**Airbag Warning Light Activated: Fault Code 1217 and/or 1218 in Airbag Control Unit Fault Memory**

Revision: This bulletin replaces bulletin Group 6, 11/04, dated July 28, 2020.

Vehicle Type: **Cayenne/Cayenne S/Cayenne Turbo**

Figure 1

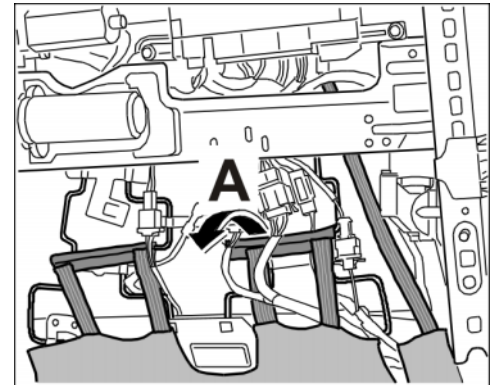
- 2.1 Disengage the right tensioning strap of the backrest cover (⇒ *Figure 1 -Arrow A-*).

Figure 2

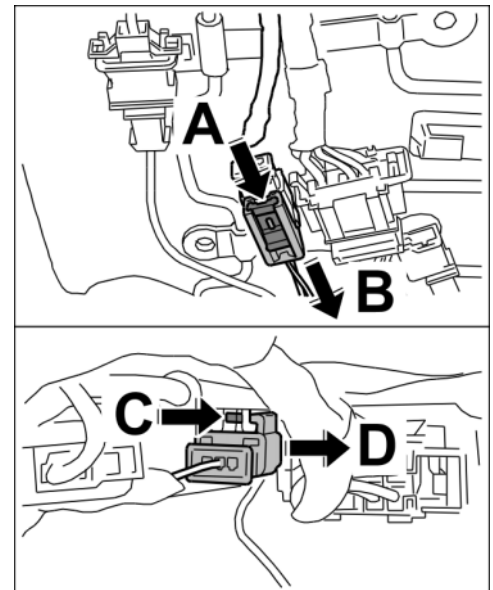
- 2.2 Push back lock on the side airbag plug (⇒ *Figure 2 -Arrow A-*) and remove from the plug socket on the side airbag (⇒ *Figure 2 -Arrow B-*).
- 2.3 Release side airbag plug at the seat frame (⇒ *Figure 2 -Arrow C-*) and push it out towards the front (⇒ *Figure 2 -Arrow D-*).
- 2.4 Unclip side airbag wire harness from the bracket on the front seat suspension. (The bracket is installed behind the control unit for memory seat adjustment).

Figure 3

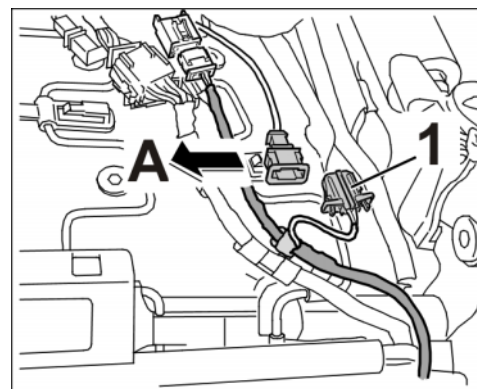
- 2.5 Release connector of ground strap from side airbag (⇒ *Figure 3-Item 1-*) and pull out of the socket.
  - 2.6 Release the rear connector bracket on the seat suspension and pull off socket for the ground strap (⇒ *Figure 3-Arrow A-*).
- 3 **Replace previous plug connection with a cable connection.**

Figure 4

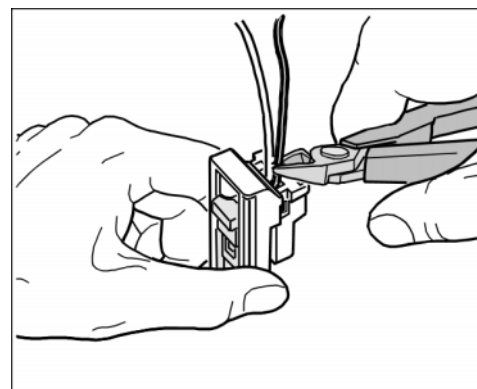
- 3.1 Position both lines of the wire harness on the control unit side flush on the connector and cut through them **individually** (⇒ *Figure 4*).
- 3.2 Position the two lines coming from the side airbag flush on the socket and cut through them **individually**.
- 3.3 Unwrap chafing prevention tape to a length of approx. 70 mm on the side airbag wire harness (clearance to slide on the shrink-fit hoses).
- 3.4 Slide a shrink-fit hose onto the **blue** line of the side airbag wire harness.

Figure 5

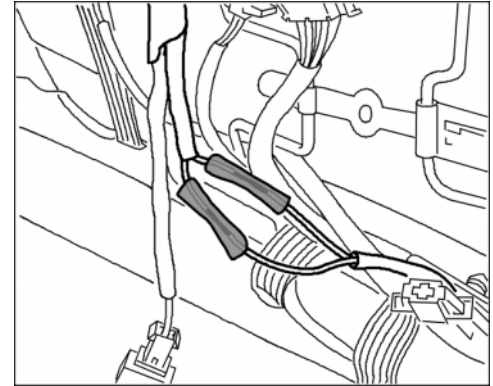
- 3.6 Position the shrink-fit hoses over the cable connections and then shrink the hoses with a hot-air gun (⇒ *Figure 5*).

Figure 6

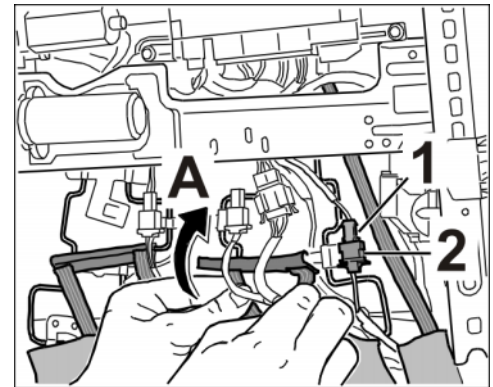
- 4.2 Clip the socket of the ground strap (⇒ *Figure 6 -Item 1-*) into the connector bracket of the rear seat suspension and connect to the connector for the side airbag ground strap (⇒ *Figure 6 -Item 2-*).

- 4.4 Engage the right tensioning strap for the backrest cover (⇒ *Figure 6 -Arrow A-*).
